ENGINEERING CHANGE NOTICE

1. ECN 636877

AX Tank Farm Waste Retrieval Alternatives Cost Estimates

HNF-2693
Revision 1

Figure 1. AX Tank Farm Waste Process Flowchart.

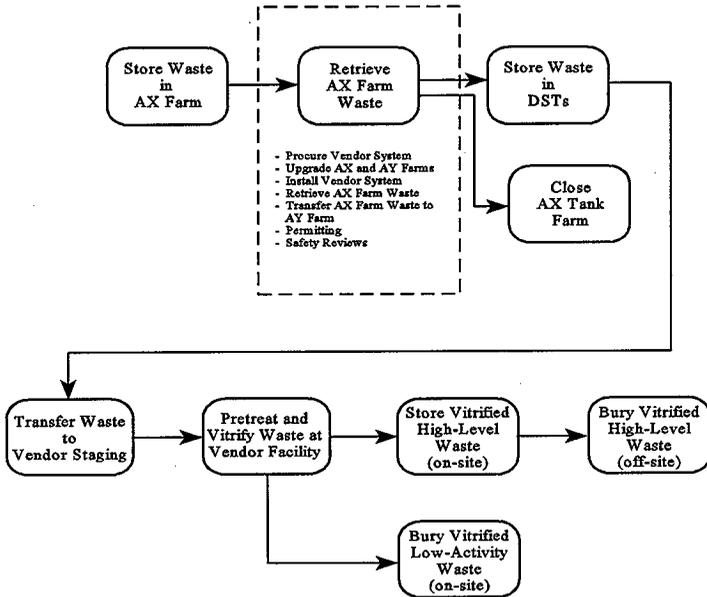
13a. Description of Change
Revisions to body of document; Replace table 1; Add figure 1; Add tables A-1 through A-5; revise appendices A, B, and C; add telecon memo to appendix E.
